C.O. BRAWNER ENGINEERING LTD.
Consulting Geotechnical Engineers

Re: Evaluation of East Pit Wall Stability

Further to the request of Mr. Colin Benner, Vice President, the stability of the east pit wall has been inspected and evaluated.

My involvement on the project has been as a Review Consultant. I wish to state that the work of A. Stewart is reasonable and I recommend you continue with his services.

FIG. 1 - RELATIVE MOVEMENT VS TIME - PRISM

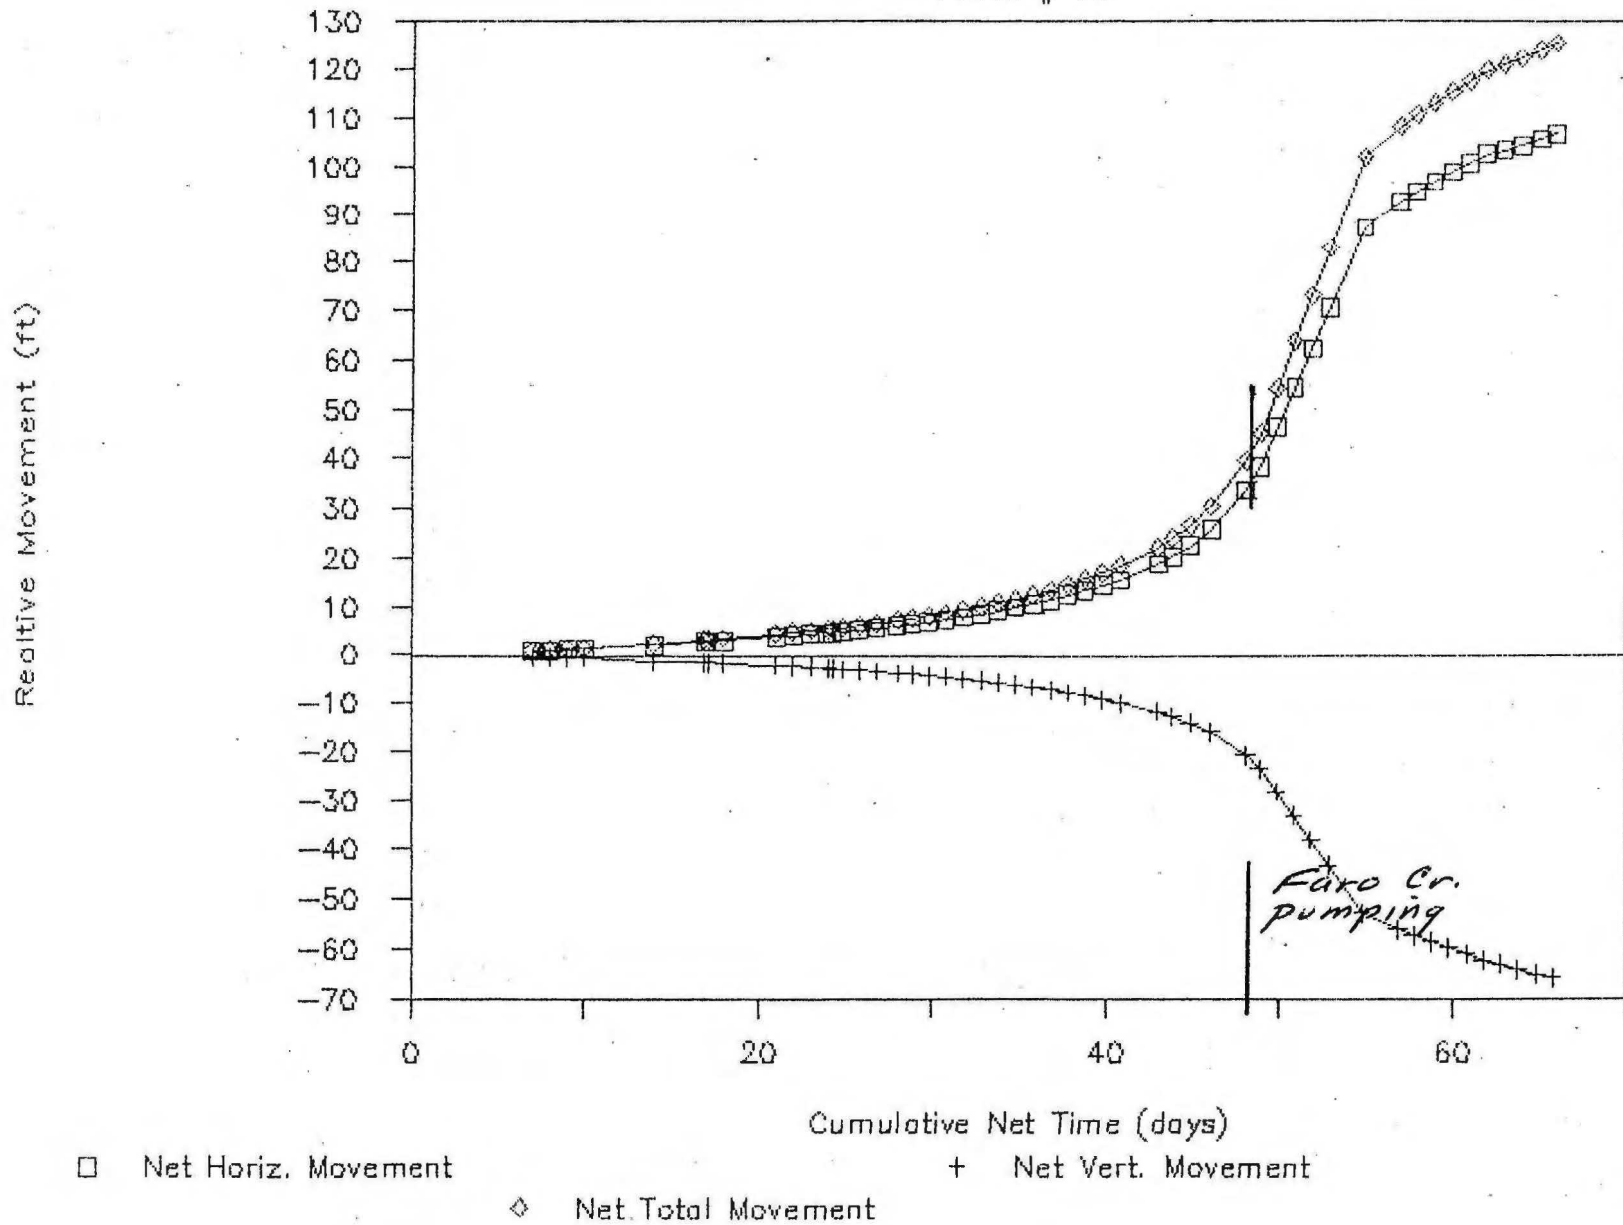
Extensive slope monitoring has been performed. Figures 1 and 2 show movement results for hubs 15 and 16 about mid-height on the slope. Horizontal movement sectors are generally much larger than vertical sectors. This indicates toppling type failure. Observation from the south end of the east slope clearly indicates toppling failure with material moving in behind as a graben, which continues to apply lateral pressure.
